CHANGES TO PROJECT DRAWINGS:

PROJECT: *Beatrice State Developmental Center - Central Heating Plant Upgrades*

DESCRIPTION: Addendum #2

BOILER DETAIL

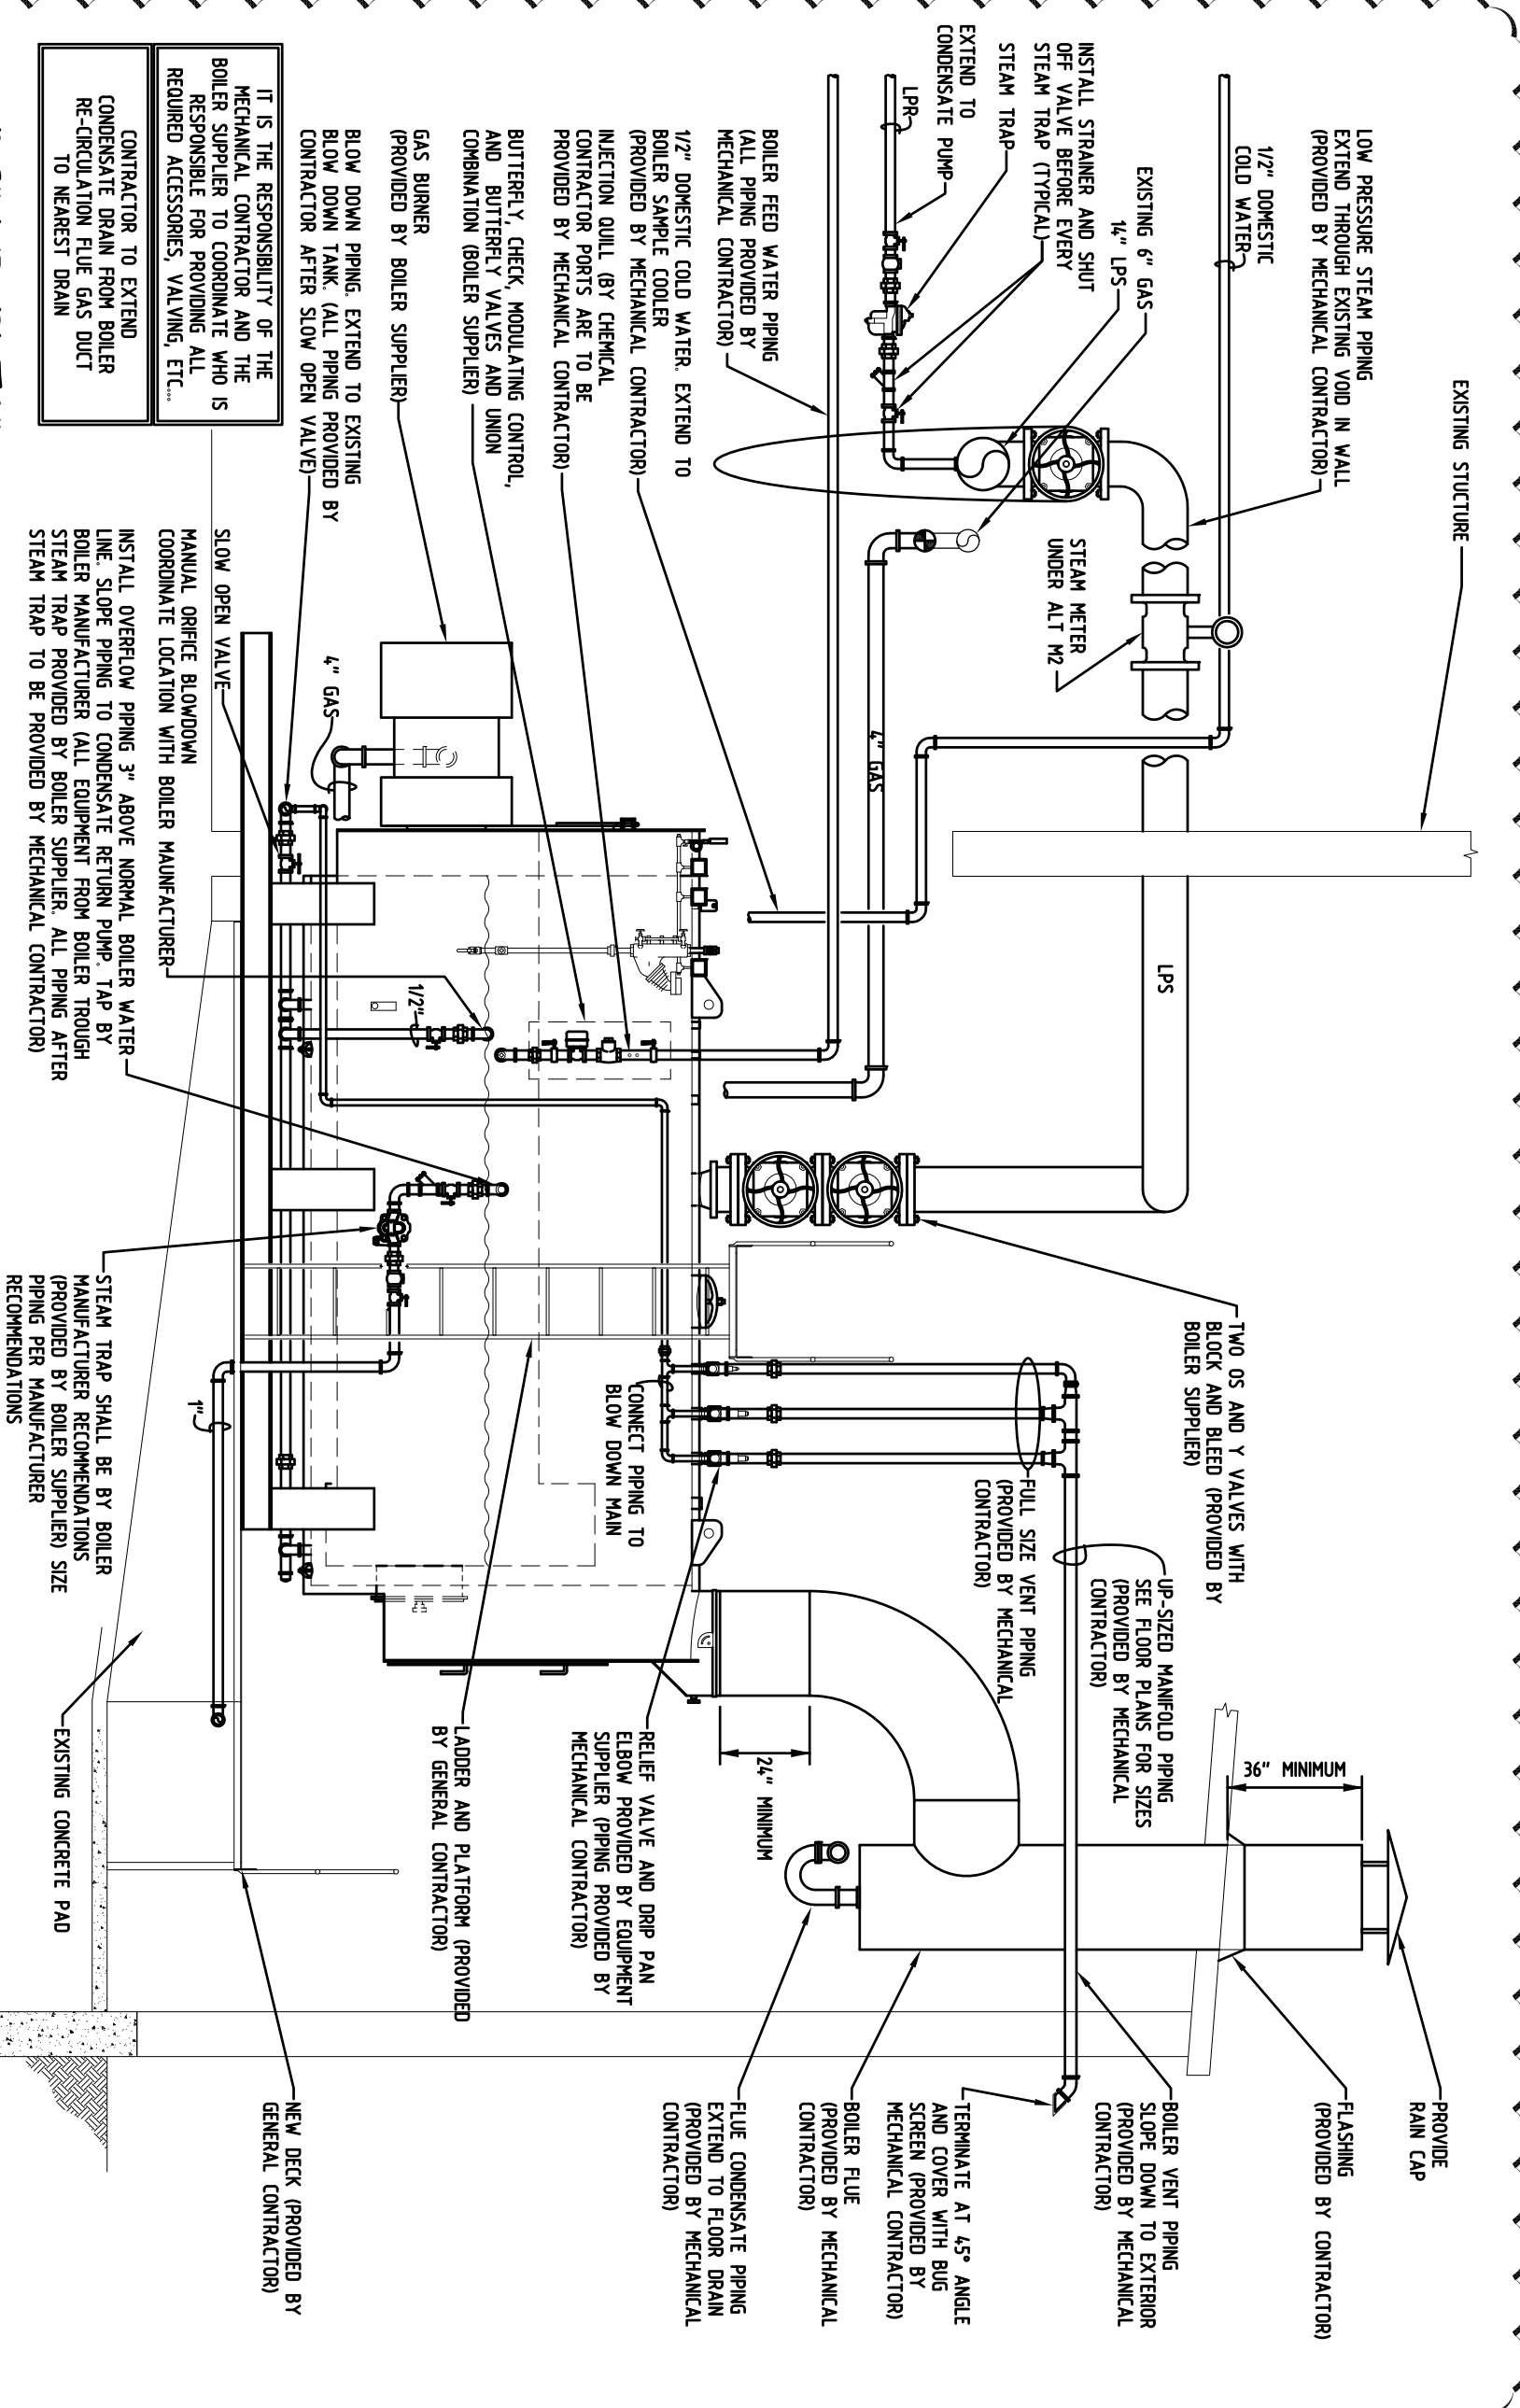
- 1) Add manual surface blow down valve and 1/2" piping to be connected to the blow down piping. Coordinate exact location with boiler manufacturer.
- 2) Overflow piping shall be 1", steam trap shall be by boiler manufacturer recommendations.
- 3) Flue condensate piping shall be copper and have a P-trap at each flue.
- 4) Contractor to extend condensate drain from boiler recirculation flue gas duct to nearest drain.
- 5) See revised detail on ADD02.25M22-2

CONTRACTOR TO EXTEND CONDENSATE DRAIN FROM BOILER RE-CIRCULATION FLUE GAS DUCT TO NEAREST DRAIN

SLOW OPEN VALVE
MANUAL ORIFICE BLOWDOWN
COORDINATE LOCATION WITH BOILER MAUFACTURER

INSTALL OVERFLOW PIPING 3" ABOVE NORMAL BOILER WATER LINE. SLOPE PIPING TO CONDENSATE RETURN PUMP. TAP BY BOILER MANUFACTURER (ALL EQUIPMENT FROM BOILER THROUGH STEAM TRAP PROVIDED BY BOILER SUPPLIER. ALL PIPING AFTER STEAM TRAP TO BE PROVIDED BY MECHANICAL CONTRACTOR)

STEAM TRAP SHALL BE BY BOILER MANUFACTURER RECOMMENDATIONS (PROVIDED BY BOILER SUPPLIER) SIZE PIPING PER MANUFACTURER RECOMMENDATIONS

S 1 MAU CONNECTION DETAIL
 25M3.1 SCALE: 1/4" = 1'-0"

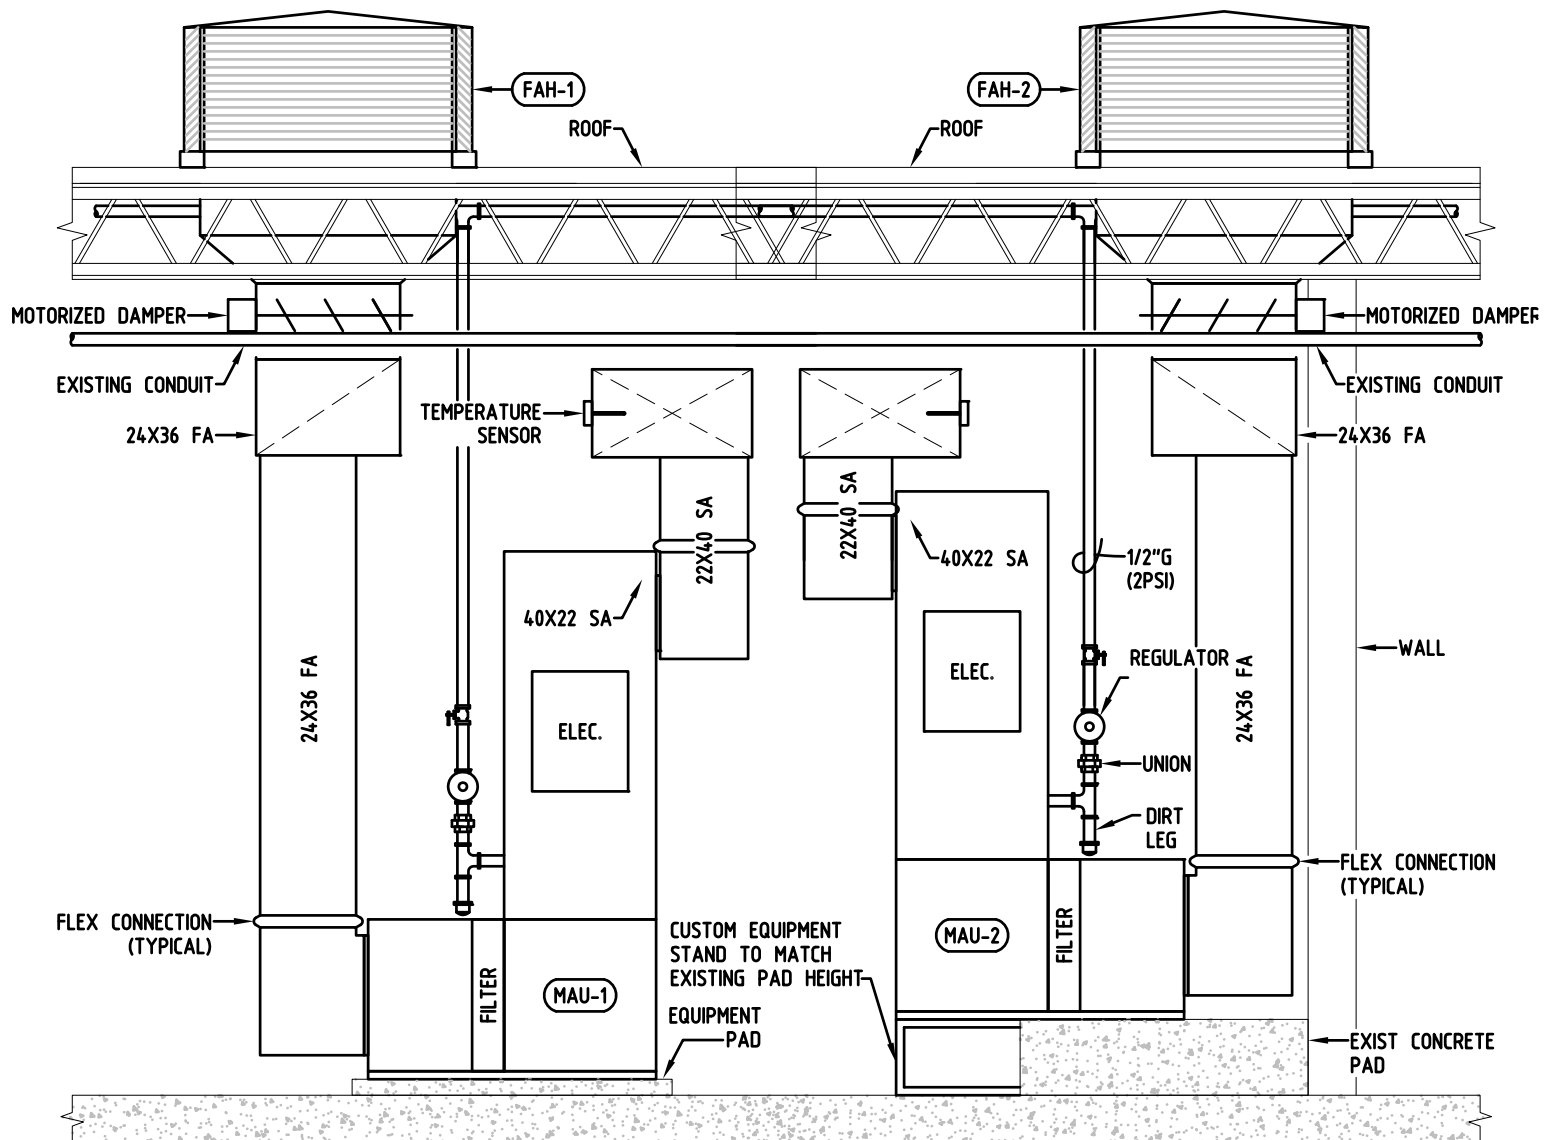
- 1) Modification to routing to accommodate existing conduit. See revised detail on ADD02.25M31-1 and ADD02.25M31-2

D 1 BOILER SEQUENCES

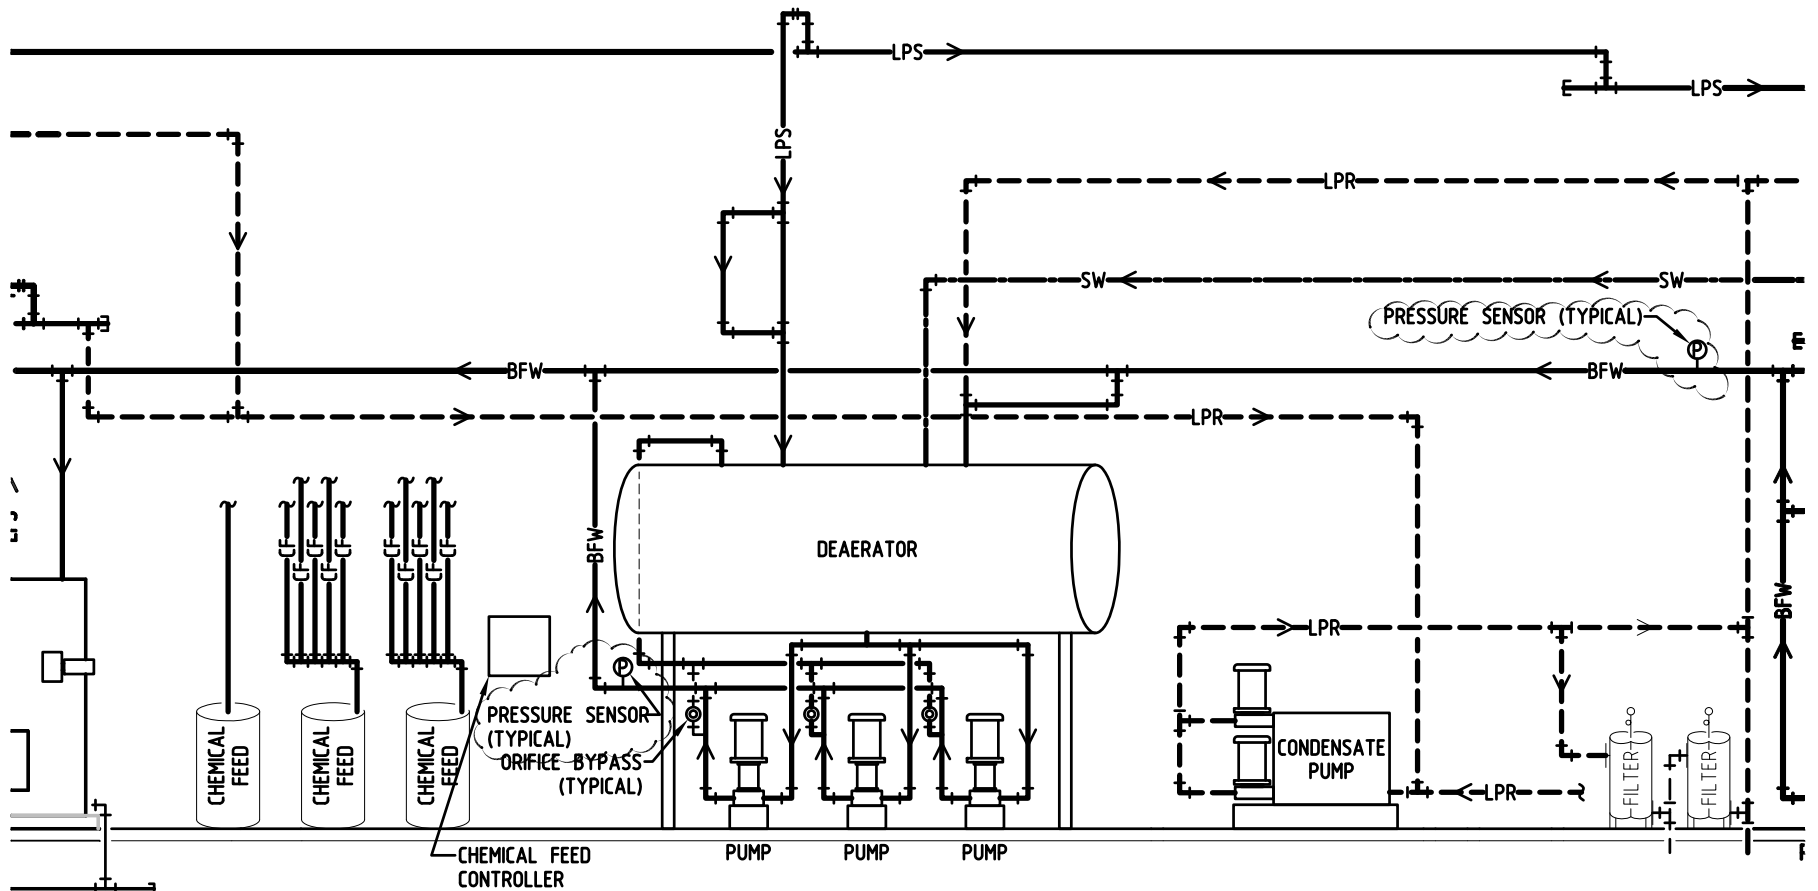
- 1) Delete the bullet that reads "the boiler air to fuel ratio shall vary automatically depending on the oxygen content in the air".

-
- 2) Under Alarms section, add bullet note to read, an audible and visual alarm shall be provided and alarm upon which ever alarms the owner chooses. Coordinate with the owner during programming.

- ALL MANUFACTURERS ALARMS ARE TO BE REPORTED TO THE BAS WITH EMAILS BEING SENT OUT TO THE RESPECTIVE PARTIES, LIST OF EMAIL ADDRESSES IS TO BE PROVIDED BY OWNER.
- A AUDIBLE AND VISUAL ALARM SHALL BE PROVIDED AND ALARM UPON WHICH EVER ALARMS THE OWNER CHOOSES. COORDINATE WITH THE OWNER DURING PROGRAMMING
- ALARMS SHALL INCLUDE BUT NOT LIMITED TO:
 - LOW STEAM PRESSURE
 - LOW/HIGH WATER ALARM
 - LOW CHEMICAL(S) LEVELS.
 - HIGH BOILER INTERNAL TEMPERATURE AND PRESSURE.
 - HIGH FIRE GAS TEMPERATURE.
